Addendum #01

Date: June 25, 2021

Project: Huntington Middle School Modernization and Addition

11 ACOUSTICAL DOOR HEAD/ JAMB @ CMU
SCALE: 3" = 1'-0"

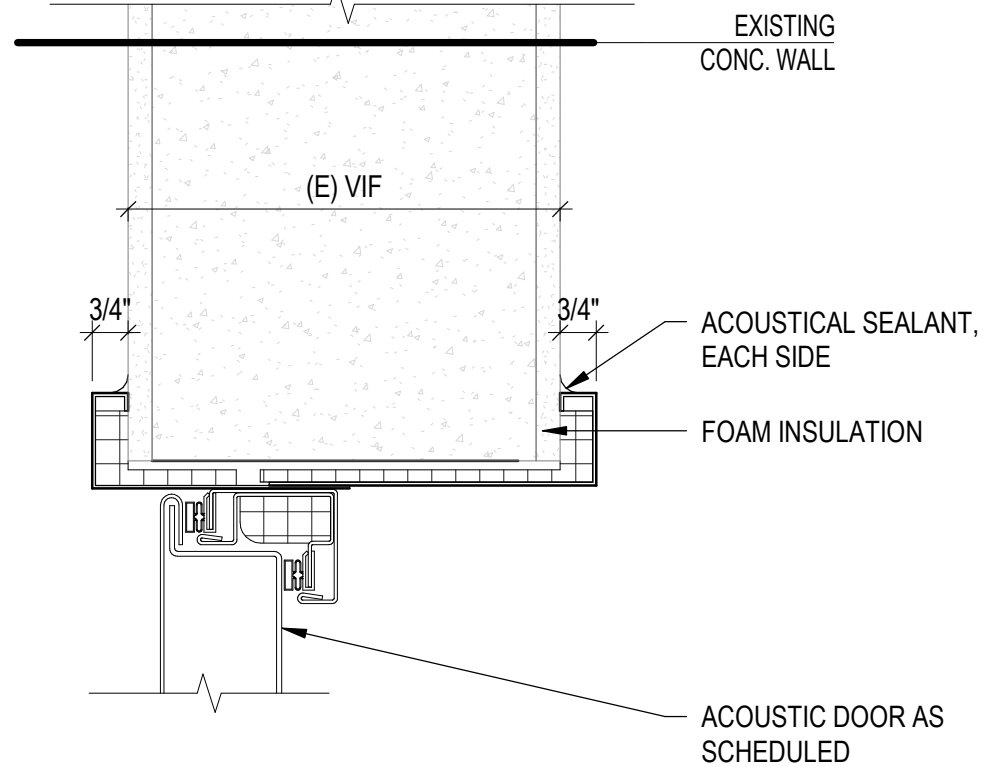
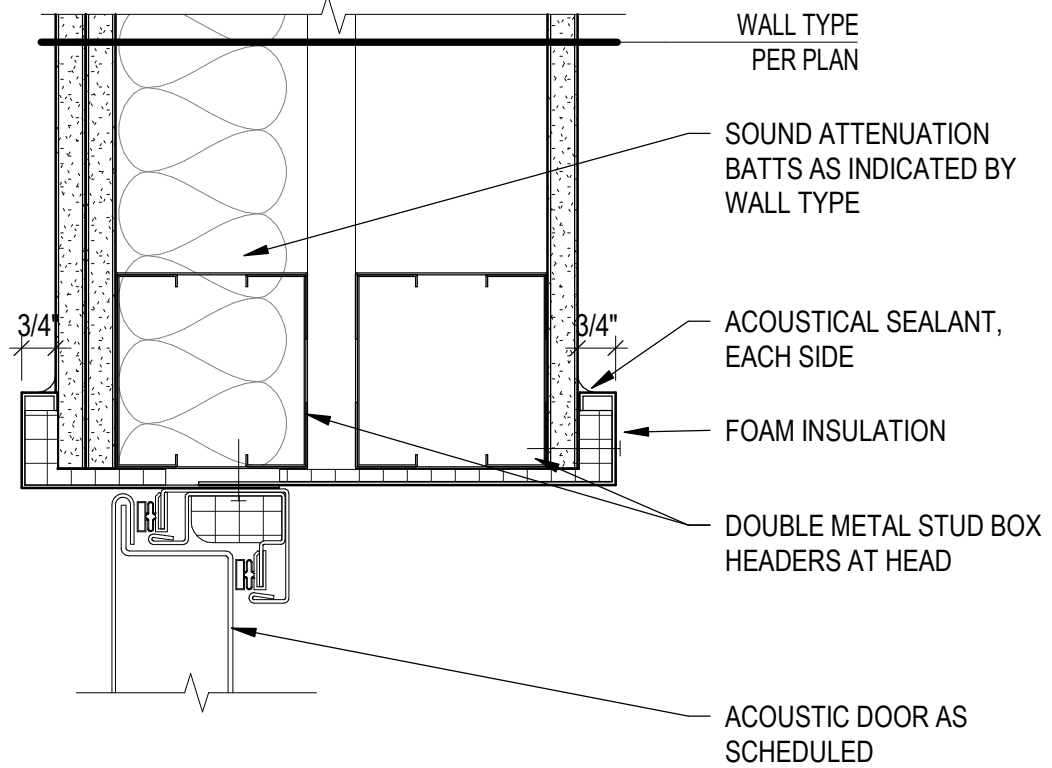
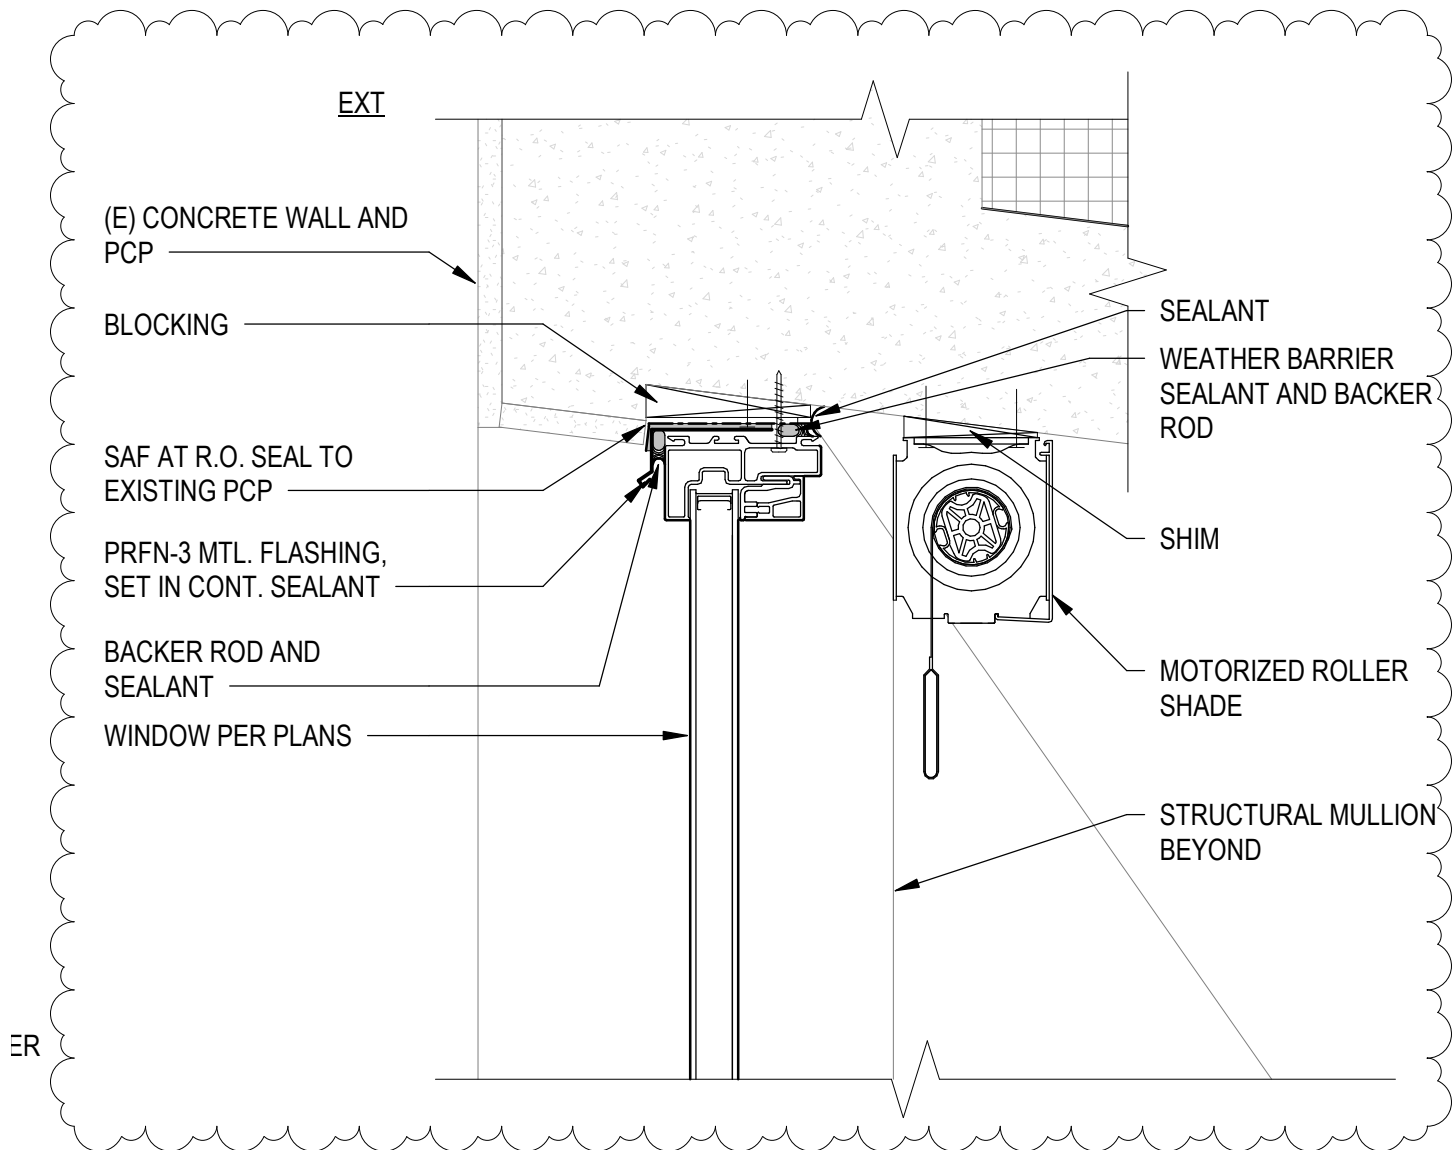
Item #A16 A612 - DOOR AND RELITE DETAILS
Add. #01 **Add** 4/A612 per attached **ADA 011**

Add 5/A612 per attached **ADA 011**

Add 11/A612 per attached **ADA 011**
